TMBR "11" State

SUNDRY NOTICES AND REPORTS ON WELLS

Plug and Abandon Procedure

PROPOSED WELLBORE
AFTER P&A

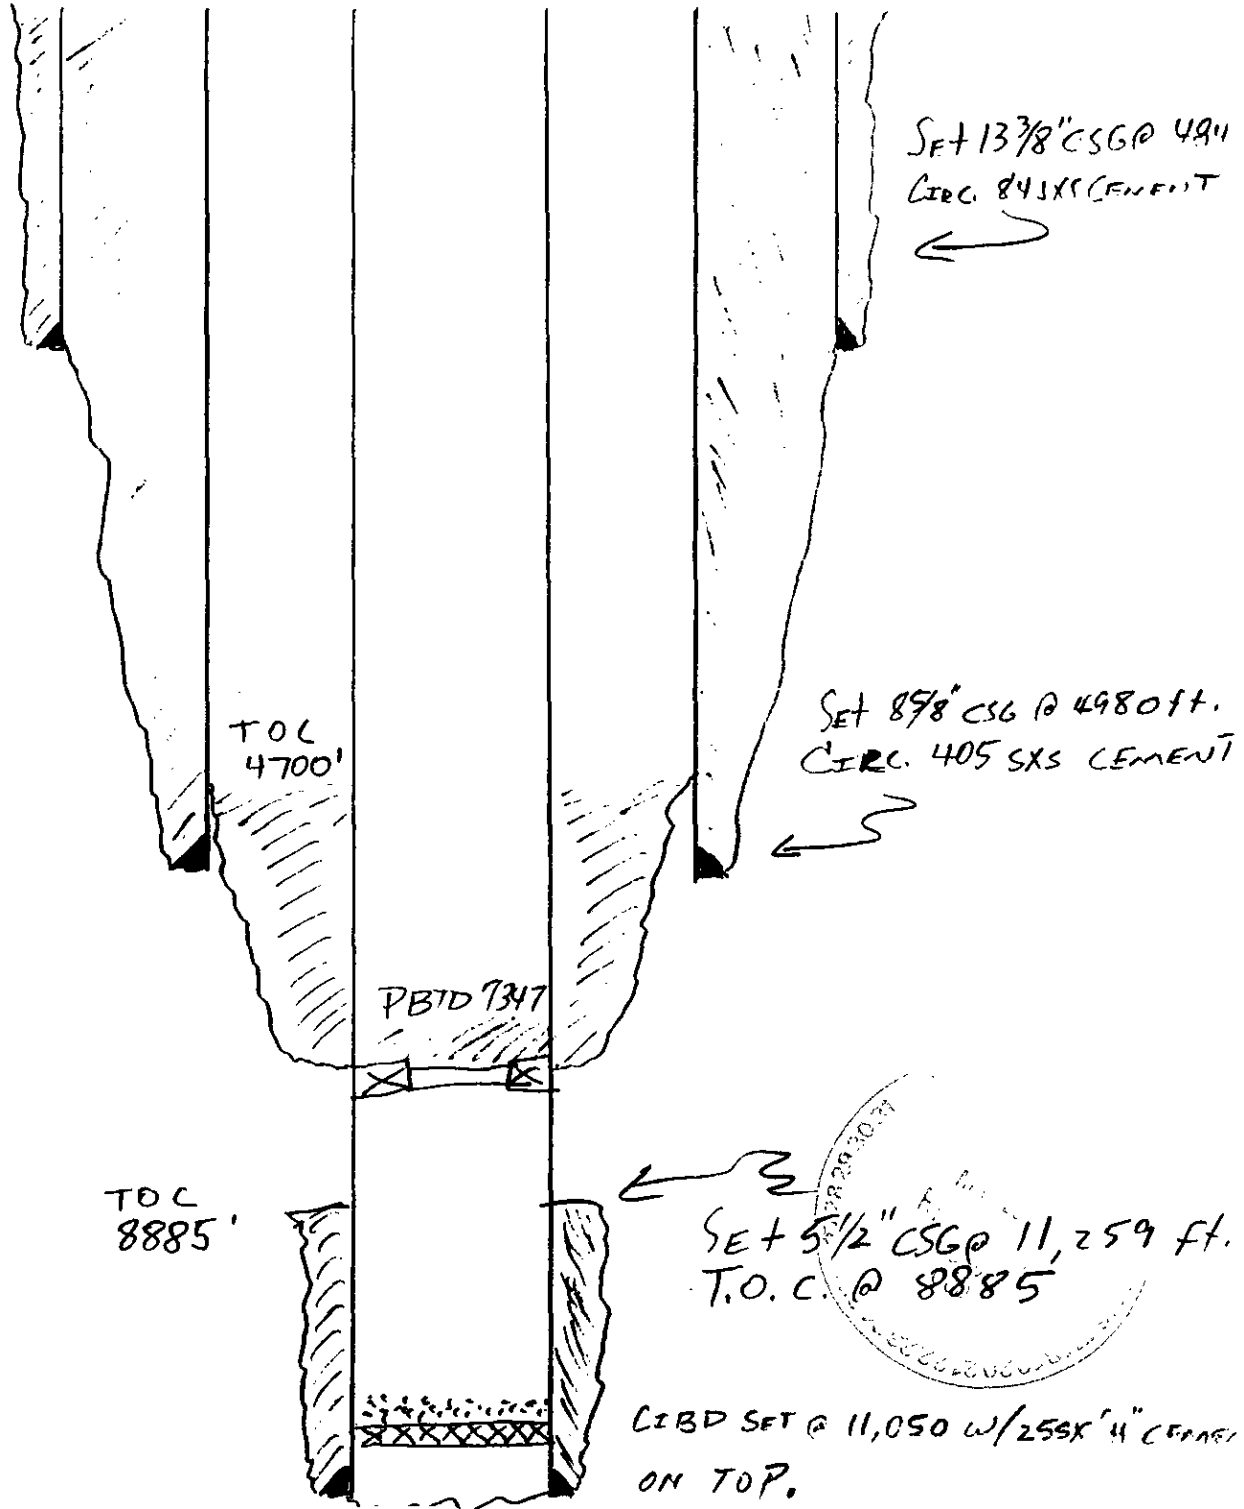
→ SPOT 100' PLUG F/5030' - 4930' - TAG
(THIS COVERS 8 5/8" CSG. SHOE)

→ SPOT 100' PLUG F/1690' - 1590' - TOP OF SALT

CONDITIONS OF APPROVAL

All shoe plugs, stub plugs & cement plugs above perforations must
be tagged

All cement plugs pumped minimum 25 sxs & be minimum 100 feet
